Life Safety Products by MTI Industries

Subject: Response to your Email and Letter of 12/1/03

In response to your letter dated 12/1/2003, I have enclosed answers to your questions about our license application.

Ionization Chamber Construction Details

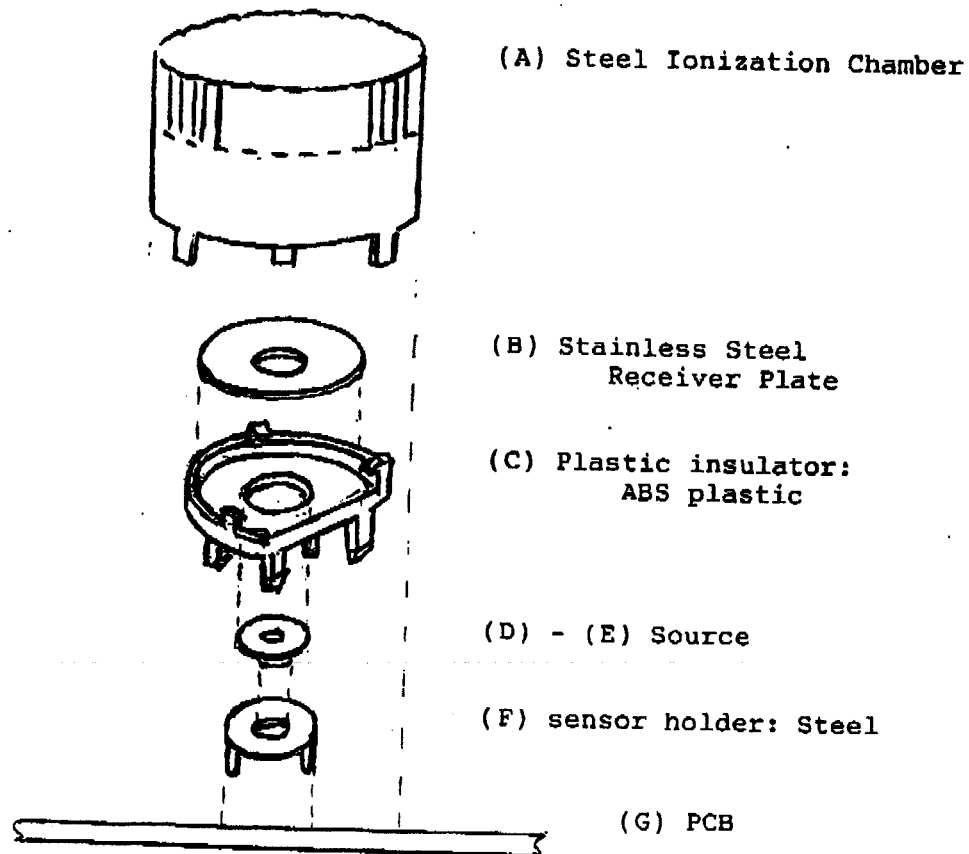
Additionally, send us a legible description of the ion chamber. Include in the description the material of construction, method of attachment of the foil source to the chamber, method of attachment of the ion chamber to the chamber support, the electronic board and to the plastic decorative housing. We would also like a sample detector (with radioactive source removed) contained in its point of sale package for our evaluation.

GARVAN'S ANSWER :General Construction Details

This chamber is held captive and soldered to the PCB after being tightened. The Chamber and PCB Assembly are held into the Plastic Housing with plastic snaps, and 2 plastic center posts which pass through the PCB. This center post is the Housing for a screw which holds the plastic assembly together. A label is placed onto the Smoke Detector to provide all required marking for the device (ie Company Name, Address, Model Number, etc.) This Smoke Detector is sealed and not intended to be opened by the Public for service or cleaning.

• (Refer to attached parts explosion)

(Item D swedged into Item E by Amersham and received as a mounted sealed source, referred to as "Source" in the following)

1. The source, Item D-E is received, after leak testing, for Assembly into the sensor holder (Item F). The outer edge of the source (Item E) is swedged against the inner lip of sensor support, Item F, in four places, displacing metal on both pieces which causes a strong interference fit between the two parts. Extreme care is taken to avoid any displacement or damage of the
